TESTIMONY IN REGARD TO 1036 ESPLANADE AND 1040 ESPLANADE

RE: Café Habana - Proposed Design Documents for VCC Submittal

1040 ESPLANADE AVE / 1324 NORTH RAMPART,

1036-1038 ESPLANADE AVE

Alley from public sidewalk showing the gate and unleveled ground surface Also shows plumbing drain cleanout and hose-bibb protrusion into alley

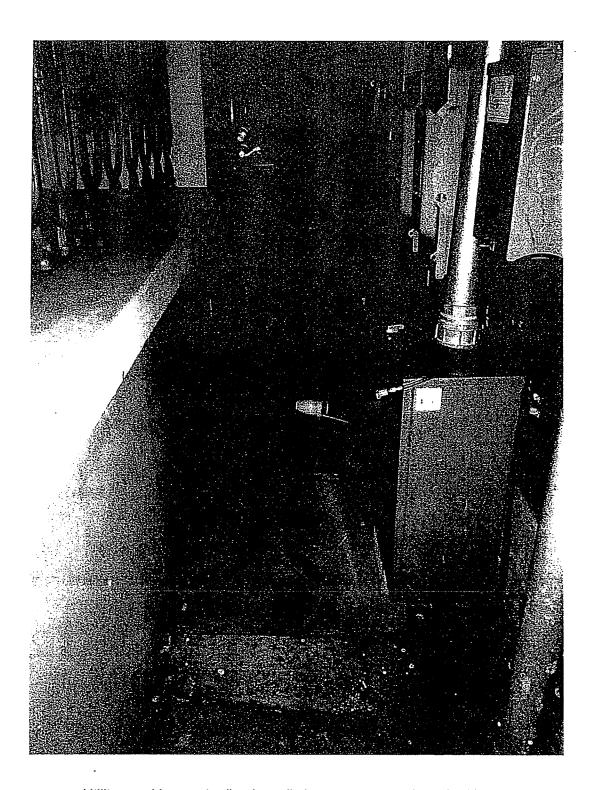
- 5. A means of egress is proposed through an alleyway between this project and the adjacent residence. That alleyway has been measured at 32 inches maximum with reduction at the gate point by utility meters and electrical panel. That route is just to the left of a door indicated as an ADA Accessible door. The indicated route of egress to the public way from that door is through this alleyway thus designating the alley as an accessible route. Investigation of the 2010 ADA/ABA adopted for review by the State Fire Marshal does not indicate that the width is sufficient for accessible egress. The minimum egress width would require not less than 44" in accordance with the NFPA 101 and IBC and additionally would require fire resistance rated corridor protection which is not indicated. Attached photographs indicate the existing electrical panel and other meters protrude into the egress width up to 10" into the clear width in an accessible route. In accordance with the 2010 ADA Standard Section 307.2, protrusion is limited between 27 and 80 inches above the floor of an accessible route to 4" into an accessible route which further precludes this alley from use as an egress route.

- b. Level route (that alleyway is not paved as required by accessibility codes and standards)
 - c. Clear width (the gate at the Esplanade Avenue sidewalk exit from the alleyway is of the required 32 inches minimum measured with the gate opened 90 degrees)

Utility panel box protruding into ally between gate and public sidewalk Note the non-level walking surface between the gate and public sidewalk
